27540 FACILITY FILE! VOLUSIA COUNTY Admin TOMOKA FADING ROAD LANDFILL Florida Department of Environmental Regulation

> Volusia County - SW Tomoka Farms Road Landfill

Re: Volusia County Tomoka Farms Road Landfill Application No. S064-121811

Volusia County - SW Tomoka Farms Road Landfill Permit No.: SO64-121811

Figure 3. Well FA-1B Schematic

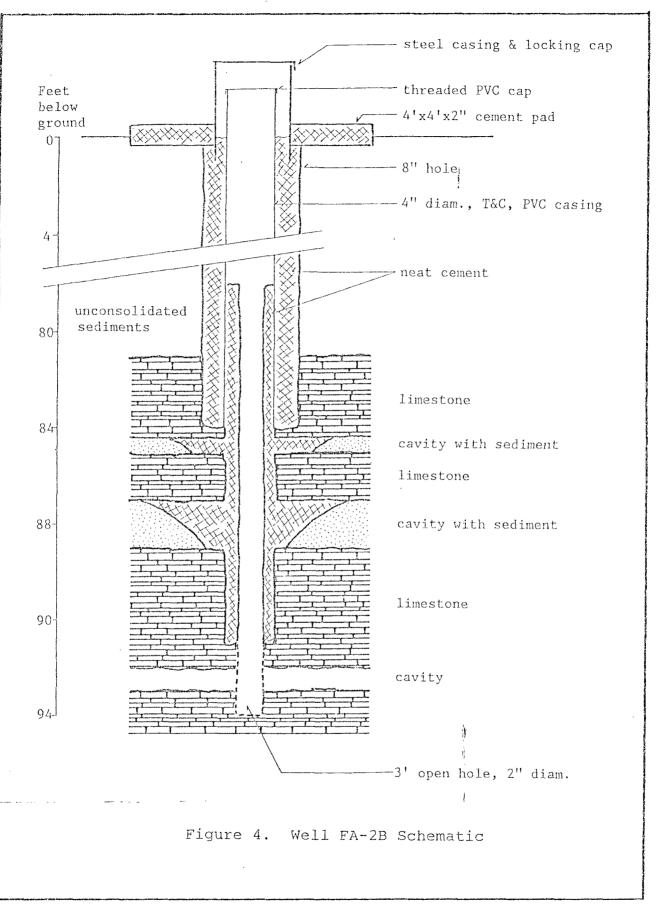
- Please provide the construction plans (illustrations) of the proposed monitoring wells which is a part of the groundwater monitoring plan. (Rule 17-7.050(3)(e), F.A.C.)

Regarding Well FA-1B, we drilled an 8" diameter hole 3 feet into limestone, using Poly-Gel drilling mud. Four-inch diameter TriLoc casing, with centralizers, was inserted to the bottom, and the annular space was then pressure grouted, through the casing, with neat cement. The well was completed 6 days later, by drilling out the cement to 1 foot below the casing, where we penetrated a thin cavity that yielded sufficient water for sampling. The well was developed by blowing with compressed air. Figure 3 shows Well FA-1B.
